HISTORIC AND DESIGN REVIEW COMMISSION

HDRC CASE NO: 2018-018
COMMON NAME: Aztec Theater
ADDRESS: 104 N ST MARYS
LEGAL DESCRIPTION: NCB 116 BLK LOT 2 THRU 9, & W 3.6 FT OF ALLEY
ZONING: D, HS
CITY COUNCIL DIST.: 1
LANDMARK: Aztec Theater
APPLICANT: Russell Williams, RA/Overland Partners
OWNER: Sam Panchevre/Aztec Family Group, LLC
TYPE OF WORK: Exterior modifications, construction of a rooftop addition, construction of a cantilevered overlook
APPLICATION RECEIVED: May 17, 2019
60-DAY REVIEW: July 16, 2019
CASE MANAGER: Edward Hall
REQUEST:

1. Construct an overlook terrace on the north façade to extend over W Crockett Street.
2. Construct a rooftop addition to feature an overall height of approximately twenty-five (25) feet.

HDRC PACKAGE — 17 MAY 2019

ELEVATION

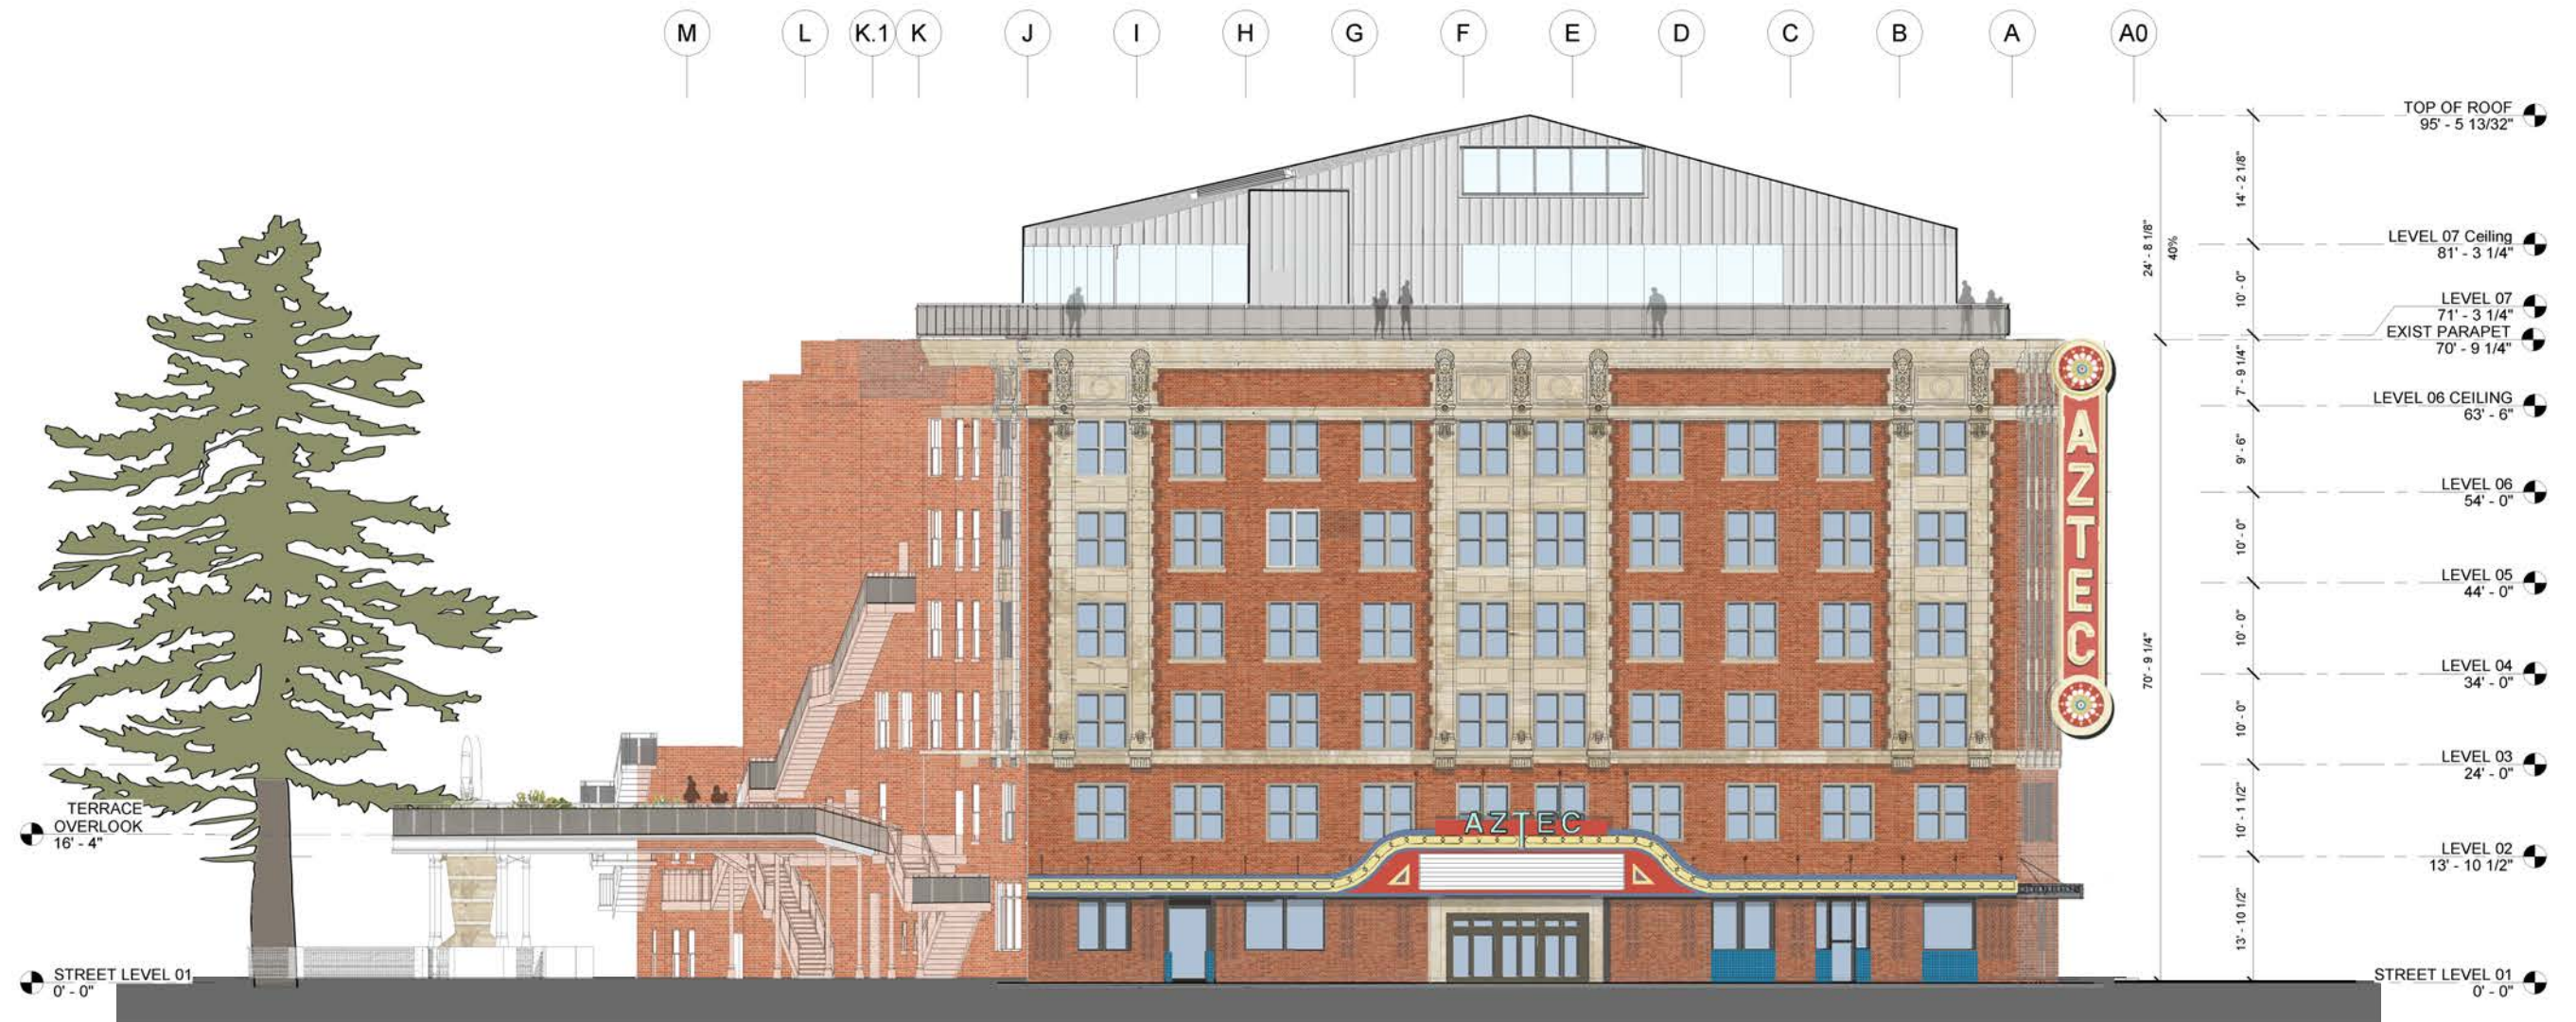
- i. **ROOFTOP ADDITION (Architectural Details)** – A proposed, the rooftop addition does not feature a symmetrical façade, an architectural detail that the historic structure has. Staff finds that the applicant should introduce a symmetrical façade on E Commerce, comparable to that of the historic structure, or align fenestrations and wall planes with the established symmetrical pattern of the Aztec Building.

- ii. That the applicant explore alternative cladding materials that complement the masonry of the historic structure.
- iii. That the applicant introduce a symmetrical façade on E Commerce, comparable to that of the historic structure, or align fenestrations and wall planes with the established symmetrical pattern of the Aztec Building.
